# UNITED STATES PATENT AND TRADEMARK OFFICE

### Office Action Summary

10/530,683

IMPELLIZZERI, FREDERIC

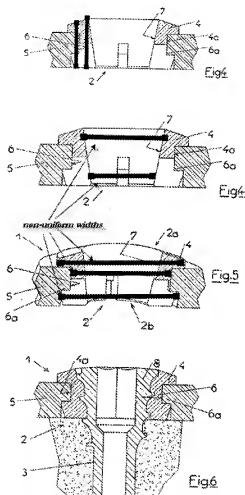
Kummer et al. disclose the claimed invention except for each tapping bone screw head having a conical shape and conical threading allowing the bone screw to be angularly received into threaded conical openings; and tapping the openings (i.e. the inner threads being positioned by the conical threading of the tapping screw head)

Frigg et al. disclose tapping bone screw heads having a conical shape and conical threading allowing the bone screws to be angularly received into threaded conical openings to achieve locking even when the bone screw is imperfectly inserted coaxially (see FIG. 1-2, col. 2, lines 1-7 and line 24).

Applicant argues that the insert width is disclosed as uniform in FIGS. 4-6. If the examiner is misinterpreting Applicant's claims and arguments, the Applicant should further clarify. As shown below, the insert does not appear to have any uniform width. Rather, the width appears variable.

opening, the examiner respectfully disagrees. As seen below, the insert clearly engages opposite surfaces of the shoulder.

Regarding Applicant's argument that Kummer et al. in view of Frigg does not show the claimed self-tapped positioning, the examiner respectfully disagrees. As seen below, the Frigg reference discloses self-tapping ability.
